Washington Grove Connector – Crabbs Branch Way Extension Facility Planning Study Briefing

Staff Recommendation: Approval to Transmit Comments

PLANNING BOARD BRIEFING
4-29-2021

Figure 5: Washington Grove Connector – Alternative #3 (Brown Street)

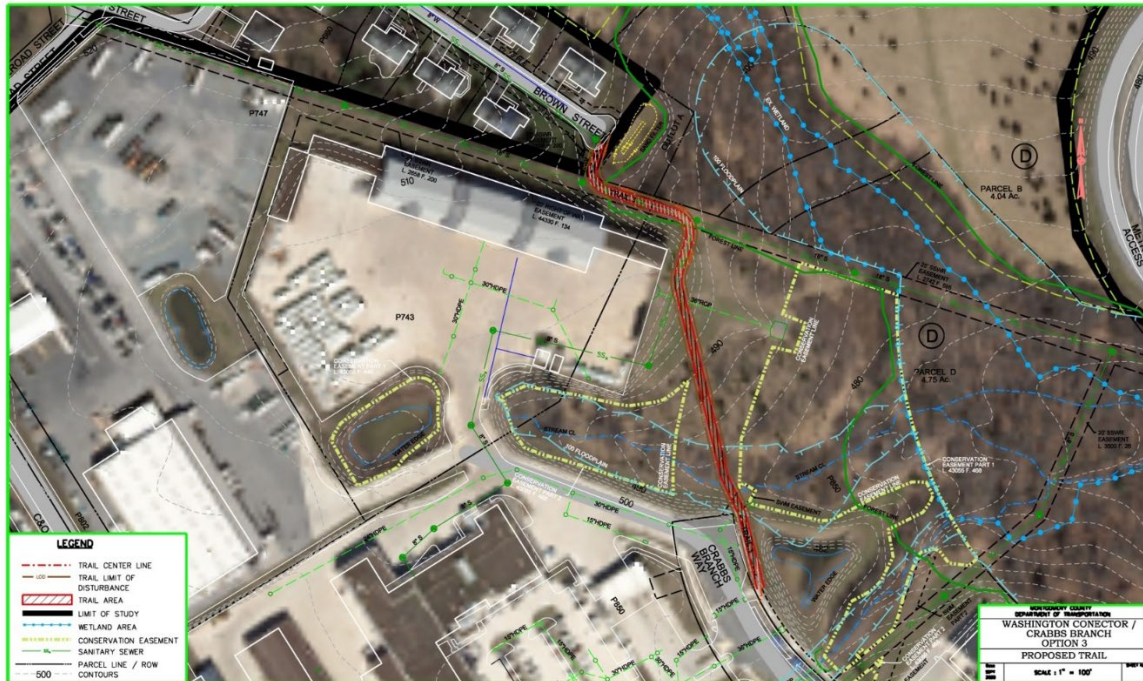
1. Washington Grove Connector Alternative #3 (Brown Street) should be advanced as the preferred trail alignment. This trail should be designed to county typical standards, including a trail width of ten feet with 2-foot wide unpaved, graded shoulders, and with no obstructions within two feet of the trail edge,

Alternative #3 is the shortest trail route (of the three primary alternatives) proposed connecting Crabbs Branch Way to Brown Street. This connection passes through M-NCPPC property, similar to Alternative #1, then travels along a short section of the WSSC easement before terminating at the existing stub end of Brown Street.

Of the alternatives advanced by MCDOT, Montgomery Parks supports Alternative #3 (Brown Street) as the most effective connection from the Washington Grove neighborhood to the end of Crabbs Branch Way. This option provides an efficient connection while minimizing impacts to natural, cultural, and historical resources outlined. Alternative #2 is not supported due to the additional impacts this alignment presents to existing forest, wetland, and meadow habitat, and potential historic/archaeological resources.

Figure 6: Washington Grove Connector – Alternative #4 (Picea View Court)

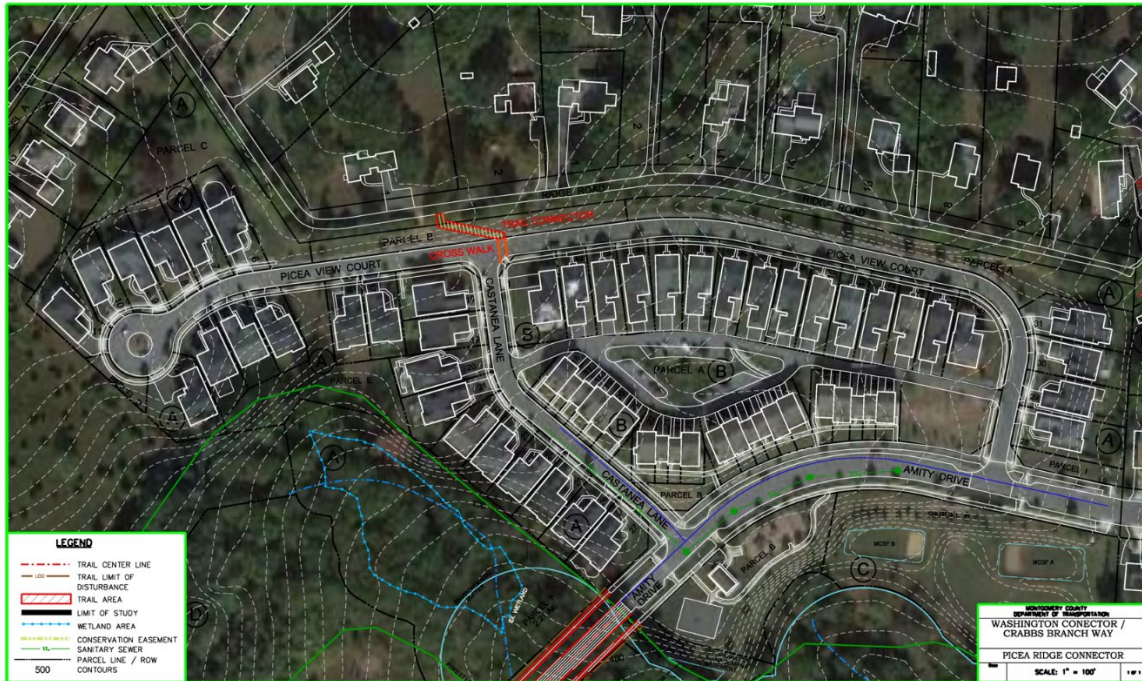
2. Washington Grove Connector Alternative #4 (Picea View Court Connector) should be advanced as an additional trail connection, as it has its own merits/independent utility for connecting the Amity Drive area with the Town of Washington Grove for pedestrians and cyclists,

Alternative #4 (Picea View Court) was identified by public comments received at the first 2020 public meeting, and this would provide a short connection between Picea View Court and Ridge Road. The intent is to provide a direct connection between the Town of Washington Grove street network and the Amity Drive neighborhood.

Figure 7: Crabbs Branch Way Extension – Plan View

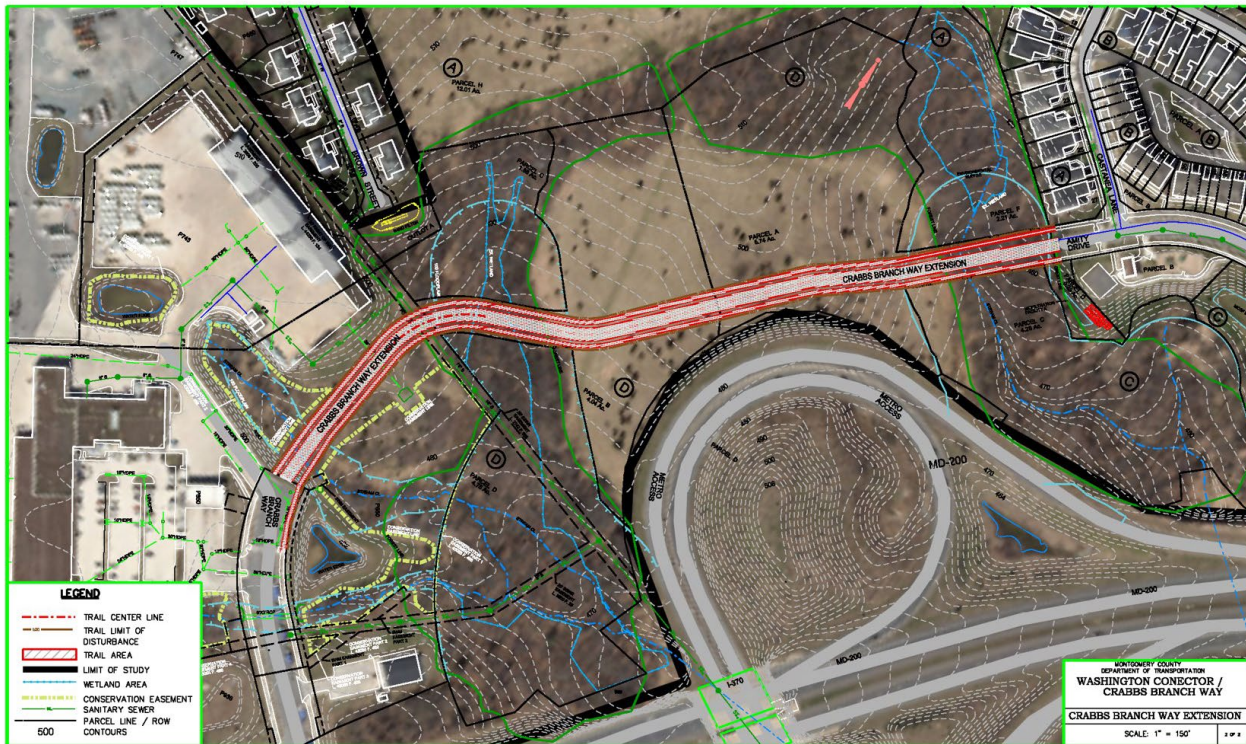
3. The cross section used to design the Crabbs Branch Way Extension should use the Neighborhood Connector street type presented in the Complete Streets Design Guidelines,

4. MCDOT should come back for a second briefing for the Crabbs Branch Way Extension project, once significant study and conclusions are reached for this facility planning study,

A concept plan was developed by MCDOT for this proposed road connection which is shown in Figure 7. This road connection is master planned as a primary residential street. The proposed cross section is shown in Figure 8.

The Crabbs Branch Way Extension between Crabbs Branch Way and Amity Drive is master planned as a Primary Residential Street in the Master Plan of Highways and Transitways. This planned connection was included in the 2006 Shady Grove Sector Plan and has been continued as a recommendation in the recent 2021 Minor Master Plan Amendment. A trail facility called the Piedmont Crossing Local Park Trail is also master planned in the Bicycle Master Plan along the general alignment of this planned road connection. It should be noted that this planned extension would likely be re-classified as a Neighborhood Connector using the ongoing Complete Streets Design Guidelines. The typical cross section on this type of street would call for a sidepath on one side of the street (which would satisfy the Bicycle Master Plan trail connection), and a sidewalk on the other side of the street. The width of the travel lanes shown in the concept for this planned extension would also call for 11-foot wide travel lanes.

Figure 9: Crabbs Branch Way Extension – Amity Drive Trail Connector

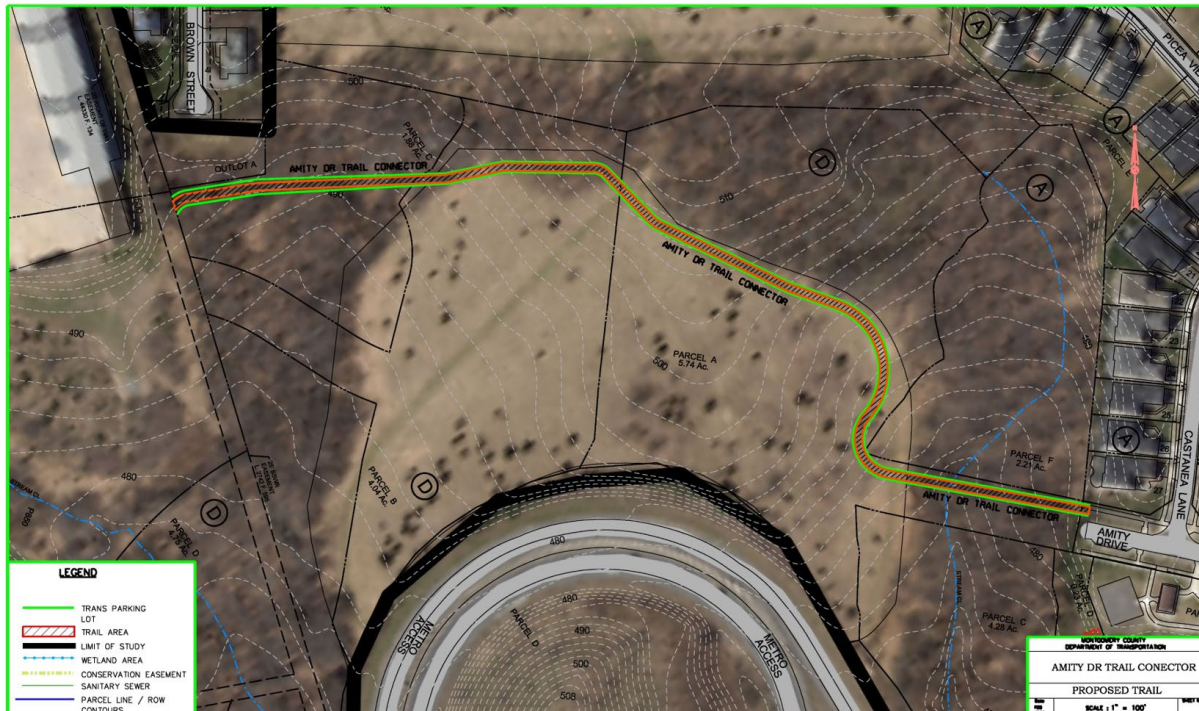
5. MCDOT should re-evaluate the need and alignment for the Amity Drive Trail Connector as presented in the briefing, as this connections could either be accomplished using the Crabbs Branch Way Extension alignment (if this road is constructed) or as a separate trail along generally the same alignment (if the road is not constructed). Montgomery Parks has concerns with the alignment shown during this briefing and has noted the existence of an unsigned, people's choice trail that would be preferable.

During the study, MCDOT also developed the Amity Drive Trail Connector, as shown in Figure 9. This trail was developed for consideration if the Crabbs Branch Way Extension project is not advanced. This trail would connect into either of the three primary alternatives studies at the WSSC easement.

The proposed Amity Drive Connector Trail would impact and replace a section of the existing natural surface trail on Piedmont Crossing Local Park. A trail connection in this location would only be considered once the evaluation of the Crabbs Branch Way Extension project is complete. If the roadway is extended, the trail alignment should follow immediately adjacent. A natural surface trail connection from the end of Amity Drive to the existing Natural Surface Trail loop in the park should be a consideration as part of the overall trail plan where an unsigned people's choice trail exists now. Signs, a kiosk at Amity Drive, and a small bridge would be needed to make this connection official. The master planned road alignment would have significant impacts to the existing recreational, environmental, and historic resources in the park.
